Response to Submissions

**Middle Creek Quarries,
via Oberon
(DA 10.2016.38.1)**

October 2016

Figure A
REGISTERED GROUNDWATER
BORES AND GEOLOGICAL SETTING

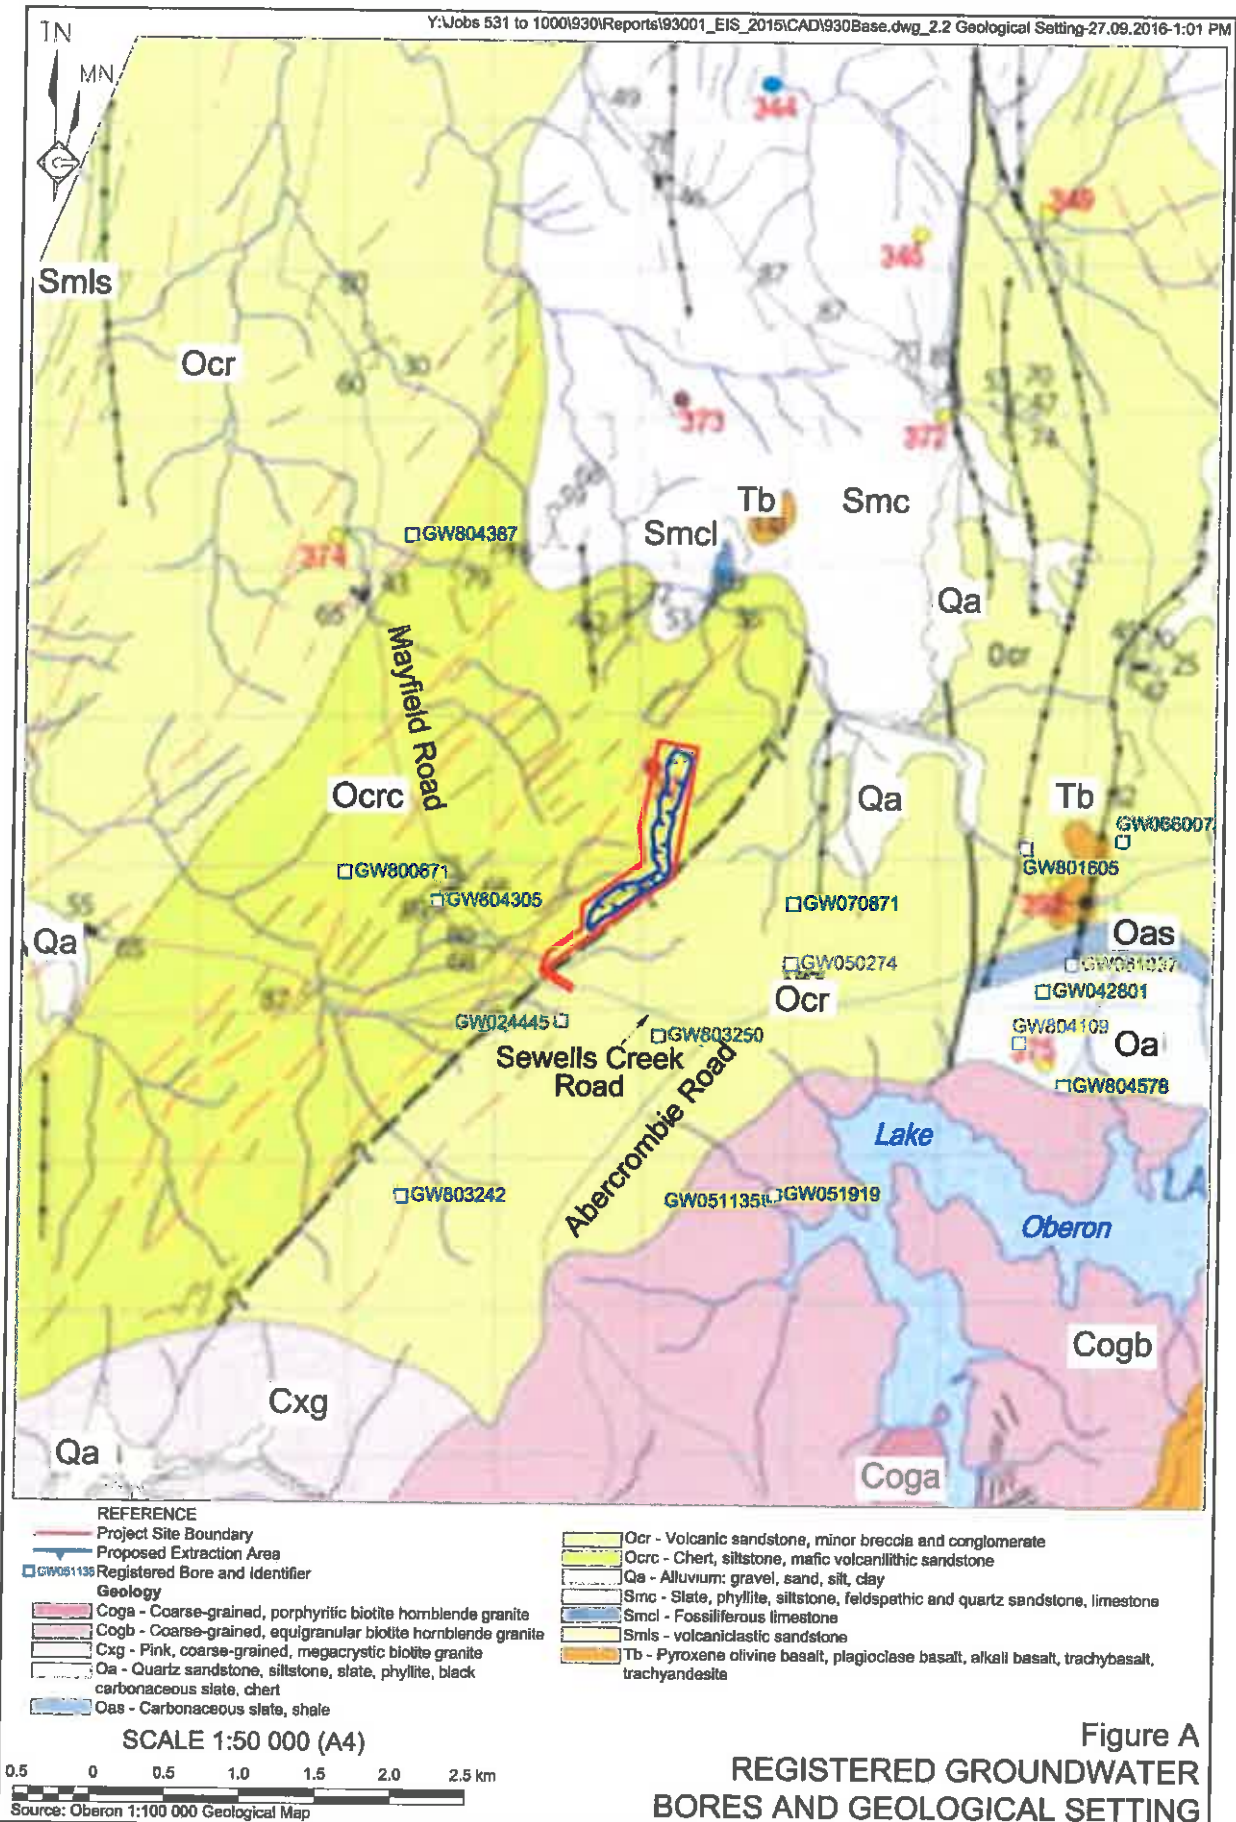
DPI Water refers to the standing water level of a neighbouring bore (GW803250) (at 22m below ground level) as potential evidence of groundwater levels at or above the proposed depth of extraction. As a point of note, the standing water level is recorded at 22m below surface, however, the water bearing zone at between 27m and 28m below surface. This places the groundwater table at between 1 120 and 1 125m AHD (as opposed to 1 128m AHD).

The EIS references the difference in the geology of the resource to be extracted as distinct to the geology of the water bearing zones of the bores surrounding the Project Site. **Figure A** further illustrates this by plotting the groundwater bore locations over the regional geology map (provided by the Oberon 1:100 000 geological map – Stewart-Smith & Wallace, 1997).

While providing information which may be used to assess groundwater occurrence, it is acknowledged that geology alone cannot be relied upon as the sole indicator of groundwater connectivity. The water bearing zones of the groundwater bores surrounding the Project Site have subsequently been analysed to identify the local geology in which groundwater has been recorded. This analysis identifies the water as predominantly within shale or basalt. This includes within GW804305 (at 1 075m AHD) which falls within the *Ocrc* geology common to the rock to be extracted (see **Figure A**).

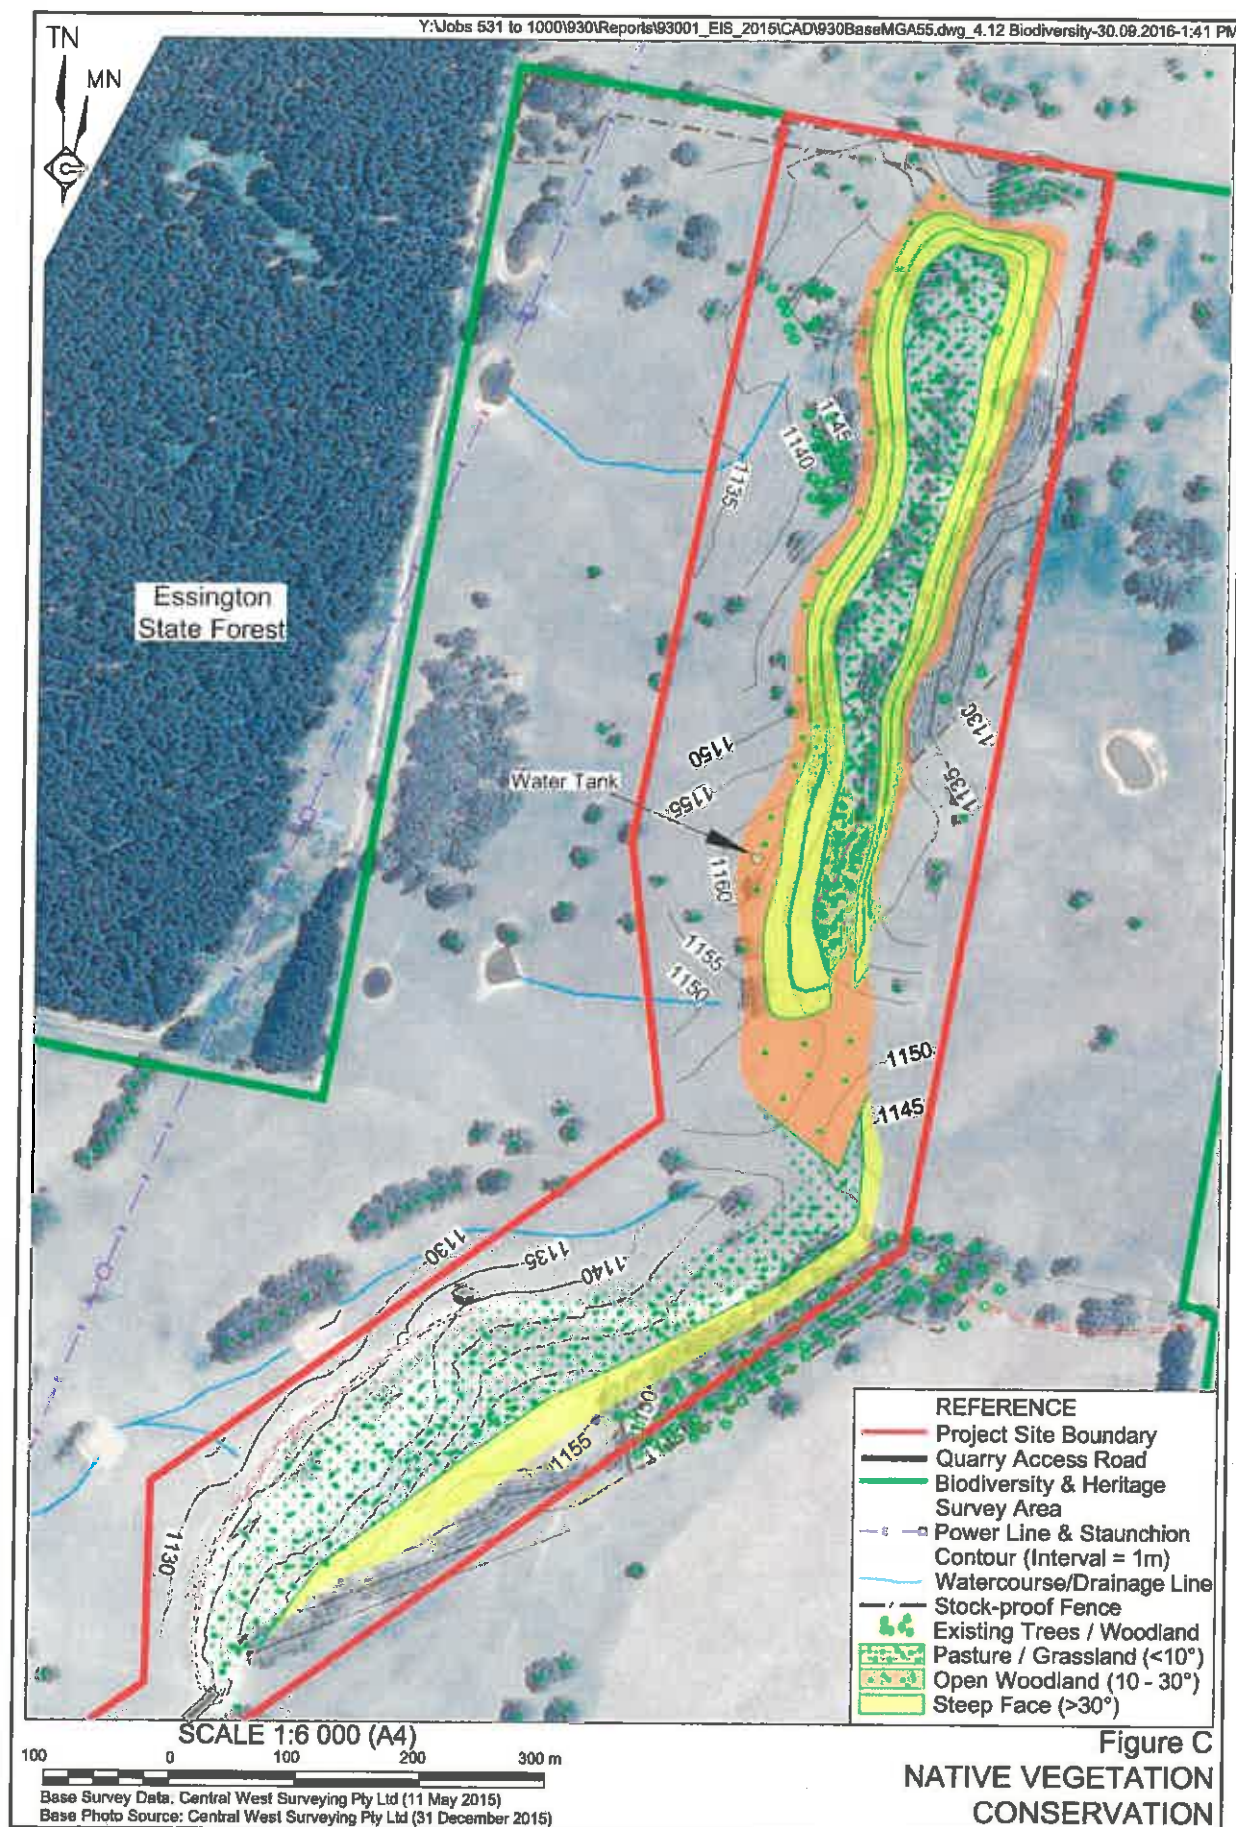
3.3 A stock proof fence be erected around the offset areas.

While no formal offset is required for the Proposal, the Applicant is committed to fencing the remnant native vegetation which adjoins the extraction area and which will be linked through rehabilitation of the final landform (see **Figure C**).

Figure 7.4: Example of a rural property access specifically designed for articulated vehicles on a two-lane two-way road

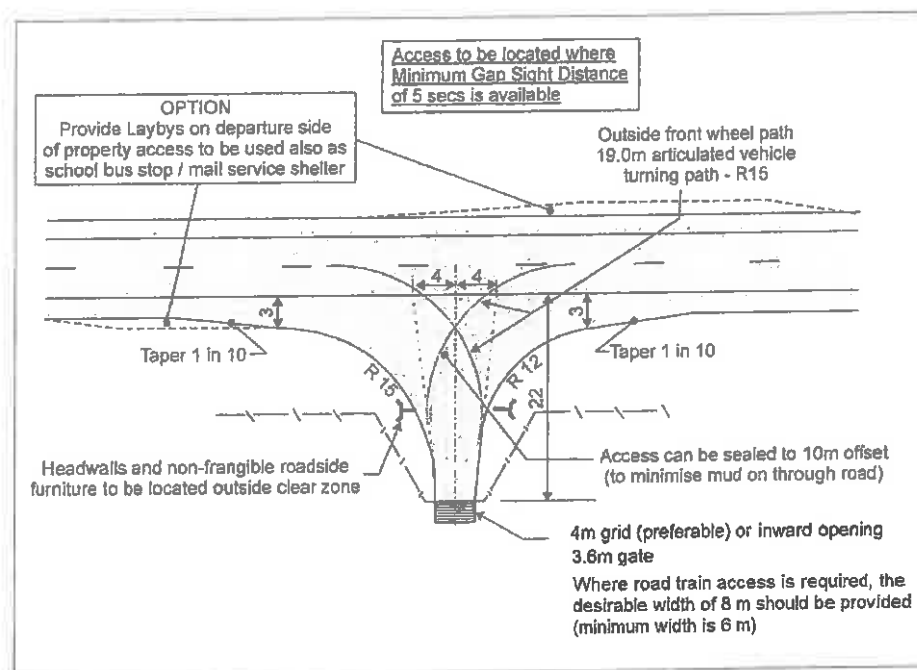
- The vehicular access servicing the development should be upgraded and maintained in accordance with *Austroads Guide to Road Design: Part 4 Figure 7.4 'standard rural property access'* (copy enclosed). The design of the vehicular access needs to ensure that vehicles exiting the site approach Sewells Creek Road at or very near to perpendicular.

Recommendation	Acceptance	Comment
The vehicular access servicing the development should be upgraded and maintained in accordance with <i>Austrroads Guide to Road Design: Part 4 Figure 7.4 'standard rural property access'</i> . The design of the vehicular access needs to ensure that vehicles exiting the site approach Sewells Creek Road at or very near to perpendicular.	Yes	The existing approach of the Quarry Access Road to Sewells Creek Road provides the requested perpendicular approach (refer to Figure 1.3 of the EIS)
A Basic Right (BAR) turn treatment constructed in accordance with <i>Austrroads Guide to Road Design: Part 4A (2010) Figure 7.5 'Type BAR'</i> should be provided adjoining the westbound travel lane in Sewells Creek Road opposite the proposed vehicular access.	Yes	As confirmed by <i>Section 2.9.1</i> of the EIS.
Safe Intersection Sight Distance (SISD) requirements outlined in the <i>Austrroads Guide to Road Design: Part 4A</i> are to be provided at the vehicular access to the development from Sewells Creek Road.	Yes	Sight distance was assessed in the EIS (<i>Section 4.6.2.2</i>) confirming sight distance of 280m to the east and 260m to the west. Both exceed the safe intersection site distance for the legal speed limit of 100km/hr (250m) (Austrroads, 2010).

Figure 7.5: Basic right (BAR) turn treatment on a two-lane rural road

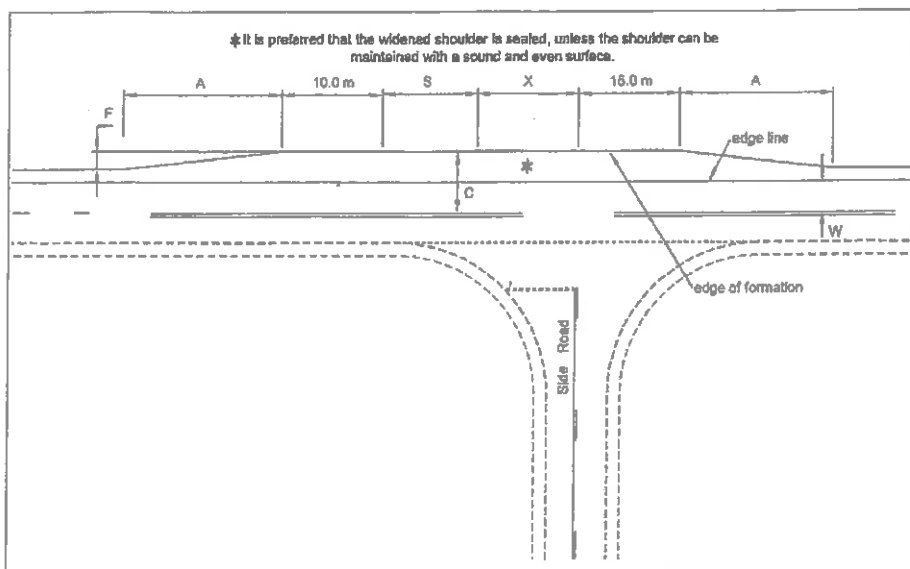
- A Basic Right (BAR) turn treatment constructed in accordance with *Austroads Guide to Road Design Part 4A (2010) Figure 7.5 'Type BAR'* (copy enclosed) should be provided adjoining the westbound travel lane in Sewells Creek Road opposite the proposed vehicular access.
